## REMARKS

## DETAILED ACTION

### Drawings

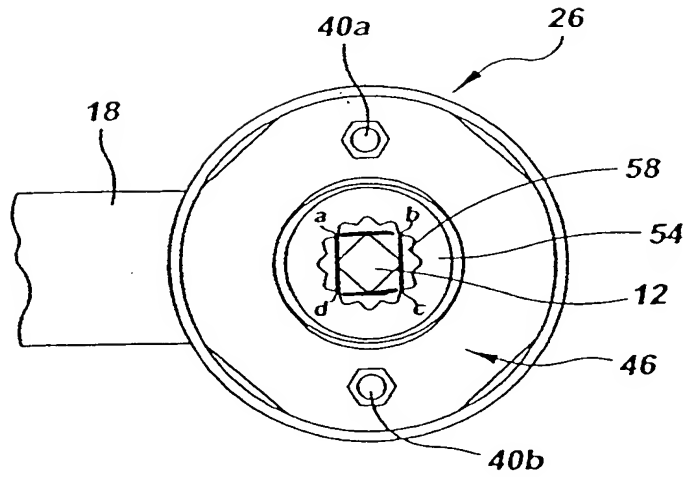
In Figures 4 and 5, clearly define the mounting plate and the mounting posts with appropriate cross-hatching. The current drawings show that the mounting posts and the mounting plate are a one-piece embodiment when they are separate members connected together (see attachment #1 point B).

In Figure 4, change the pointing line position of element 40b' (see attachment #1).

In Figure 5, change the pointing line position of element 48' (see attachment #1).

In Figs. 4 and 5 amendments were made to conform the figures to the specification. Thus, cover 26 is shown having the lip 34 with internal threads 35. The mounting plate 46 is shown having lip 48 with external threads 49. The external threads 49 of mounting plate 46 are screwed into threads 35 of lip 34 of cover 26.

Also, in Figs. 4 and 5 the lead line for 40b' was moved to the head of mounting pin 40b. Also, numeral 60c was added to show the end of anchor 60 which is inserted into the opening in spindle 12. Internal threads are shown in cap nut 54 and external threads 24 are shown at the end of handle 18.

**FIG.2**

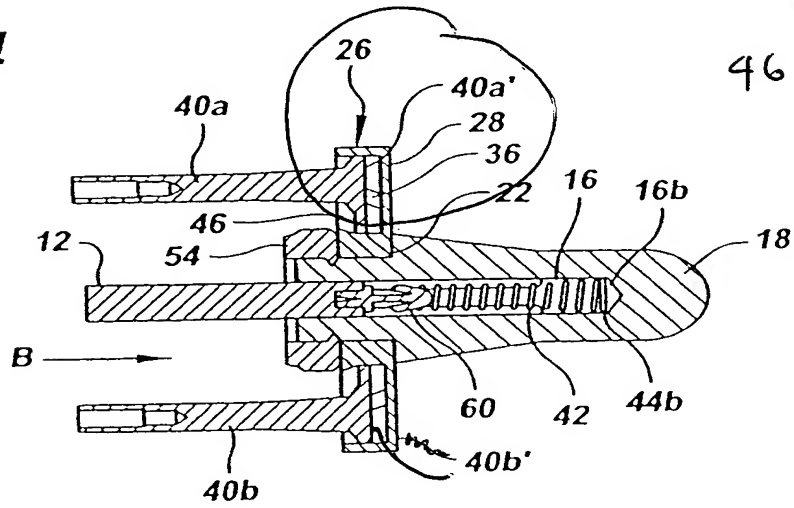
In Figure 2, change "10" to -- 18 --.

Referring to Fig. 2, Applicant shows the internal threads 35 in lip 34 of cover 26 and has corrected the numeral "10" handle to -- 18 -- .
